Application No.	Applicant(s)			
Office Action Comments	10/593,517	FREEMAN, ALAN JOHN MORRIS			
Office Action Summary	Examiner	Art Unit			
	ALEXANDER B. COMLEY	3746			
The MAILING DATE of this communication app Period for Reply	ears on the cover sheet with the c	orrespondence address			
A SHORTENED STATUTORY PERIOD FOR REPLY IS SET TO EXPIRE 3 MONTH(S) OR THIRTY (30) DAYS, WHICHEVER IS LONGER, FROM THE MAILING DATE OF THIS COMMUNICATION. - Extensions of time may be available under the provisions of 37 CFR 1.136(a). In no event, however, may a reply be timely filed after SIX (6) MONTHS from the mailing date of this communication. - If NO period for reply is specified above, the maximum statutory period will apply and will expire SIX (6) MONTHS from the mailing date of this communication. - Failure to reply within the set or extended period for reply will, by statute, cause the application to become ABANDONED (35 U.S.C. § 133). Any reply received by the Office later than three months after the mailing date of this communication, even if timely filed, may reduce any earned patent term adjustment. See 37 CFR 1.704(b).

DETAILED ACTION

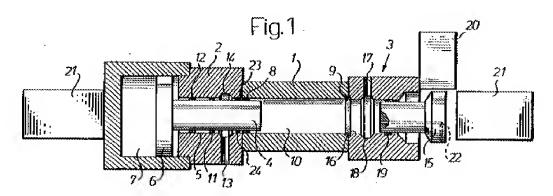
In regards to Independent **Claims 1 and 11**, and with particular reference to Figure 1 shown immediately above, Bergman discloses a pressure intensifier assembly for pressurizing foodstuffs such as tomato sauces, fruit-based pulps, and quenelles (See Col. 1, Lines 20-25). Bergman's device utilizes a cylinder-and-piston 1, 4 (i.e. barrel assembly), pressurize generator (4-7), end closure assemblies (2, 3), and a surrounding tension frame with clamping pistons 21 (See Col. 6, Lines 17-36) Just like Applicant's tension frame and clamping pistons, the tension frame/pistons (20, 21) of Bergman are designed to press against the end closures (2, 3) in order to take up any axial forces placed thereon during pressurization inside chamber 10 (See Col. 7, Lines 4-17) Bergman's intensifier also appears to operate in the same manner as Applicant's invention (See Col. 7, Line 52 – Col. 8, Line 34)

8. In regards to dependent **Claims 2 and 12-14**, the tension frame/pistons 21 take the form of a clamping yoke. Regarding dependent **Claims 3 & 15**, first and second seal assemblies (8, 9) are disposed on either end of the high pressure barrel 1. In regards to dependent **Claims 4 & 16-17**, the pressurizing means (4-7) is a hydraulic piston/ram assembly (See Col. 8, Lines 3-10) Regarding dependent **Claims 5 & 18**, the surrounding housing of Bergman's intensifier acts as a stand. In regards to dependent **Claims 6-7 & 19-20**, it can be seen in Figure 1 that no screws are utilized in retaining the various intensifier components together. Moreover, Bergman specifically states that his structure allows for quick disassembly thereof (See Col. 5, Lines 49-54) Hence, the barrel 1 can be opened rapidly, and therefore allows for quick detachability thereof.

Regarding dependent **Claims 8 & 21**, it can be seen in Figure 1 that the right end closure 3 is retractable via its plunger member 15 when the press frame pistons 21 retract therefrom (See Col. 8, Lines 27-34) And finally, in regards to dependent **Claims 9 & 22**, it is clear that the pressurizing fluid lifts the piston 4 of the barrel assembly during pressurization.

13. In regards to Applicant's argument against use of Bergman's press frame (20, 21) as Applicant's "clamping piston", the Examiner must respectfully disagree. The press frame 21 and spacing block 20 appear to make up a tensioning frame (i.e. clamping piston) that takes up the axial load forces and loads exhibited by the piston-and-cylinder mechanism during pressurizing. As such, Bergman's frame appears to be structured in the manner as Applicant's claimed invention. Applicant goes on to argue that the press frame of Bergman undergoes a cyclic load with every pressure cycle, and as such, cannot read upon Applicant's claim. However, the examiner must assert that Applicant does not appear to claim anything with regard to avoiding such a cyclic load. The press frame (20, 21) of Bergman preloads the ends of the barrel assembly in the same manner as Applicant's claimed invention, and therefore, reads upon the claim.

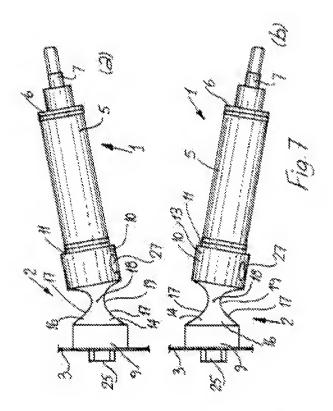
With reference to Figure 7 pictured above, Jansson discloses the use of a hinged pivot mechanism (14-19) for allowing a ram mechanism to pivot on its base (See Col. 5, line 60 - Col. 6, Line 28) Both Bergman and Jansson are aimed at providing better ram apparatuses. Therefore, to one of ordinary skill desiring a more versatile ram, it would have been obvious to utilize the pivoting techniques disclosed in Jansson in combination with Bergmann in order to obtain a predictable result; that result being a pivoting ram housing that allows for better access thereto.
